# UNITED STATES PATENT AND TRADEMARK OFFICE

APPLICATION NO.	FILING DATE	FIRST NAMED INVENTOR	ATTORNEY DOCKET NO.	CONFIRMATION NO.
10/643,557	08/18/2003	Li Ping Chen		4936

# Office Action Summary

### **DETAILED ACTION**

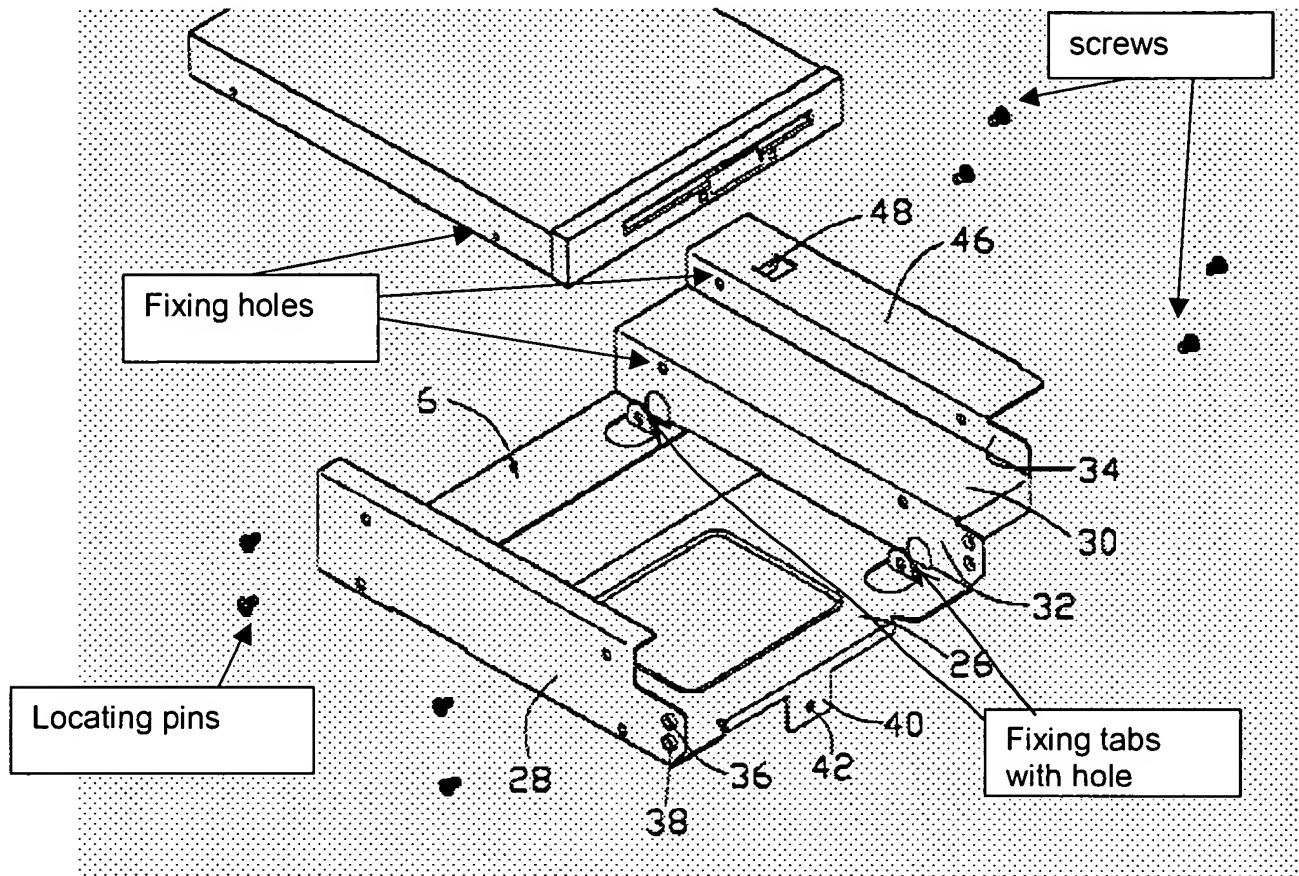
Claims 1 and 7 stand rejected under 35 U.S.C. 102(e) as being anticipated by Chen et al (US Publication no. 20040047122). Chen discloses a mounting bracket (10) for holding a data storage device (30), the data storage device comprising first and second sidewalls, the first sidewall defining a plurality of fixing holes (32) therein, the mounting bracket (10) comprising: a bottom wall (12); a first sidewall (14) extending upwardly from a side of the bottom wall with a plurality of locating pins (144) protruding inwardly therefrom corresponding to the fixing holes of the data storage device; a

second sidewall (16) extending upwardly from an opposite side of the bottom wall for sandwiching the data storage device with the first sidewall; and locking means (164 for receiving screws) for engaging with the second sidewall of the data storage device to retain the data storage device in the mounting bracket.

Claims 1, 2, 7, and 13 stand rejected under 35 U.S.C. 102(e) as being anticipated by Liao et al (US patent no. 6,529,373). Liao discloses a mounting bracket (figure 4) for holding a data storage device (8 and 10), the data storage device comprising first and second sidewalls, the first sidewall defining a plurality of fixing holes (figure 4) therein, the mounting bracket (see illustration below) comprising: a bottom wall (26); a first sidewall (28) extending upwardly from a side of the bottom wall with a plurality of locating pins (screws figure 4) protruding inwardly therefrom corresponding to the fixing holes of the data storage device; a second sidewall (30, 32, 34) extending upwardly from an opposite side of the bottom wall for sandwiching the data storage device with the first sidewall; and locking means (other wall also has screws figure 4) for engaging with the second sidewall of the data storage device to retain the data storage device in the mounting bracket; wherein the second sidewall of the mounting bracket comprising a first vertical wall (32 or 34), a connecting wall (30) and a second vertical wall (32 or 34); wherein the first wall defining a plurality of fixing holes and the fixing structures comprise a plurality of through holes defined in the first vertical wall of the mounting bracket, and screws (figure 4) extending through the through holes to engage with the data storage device; wherein a plurality of fixing tabs (see illustration below)

extends upwardly from the bottom wall parallel to and spaced from the second sidewall of the mounting bracket.
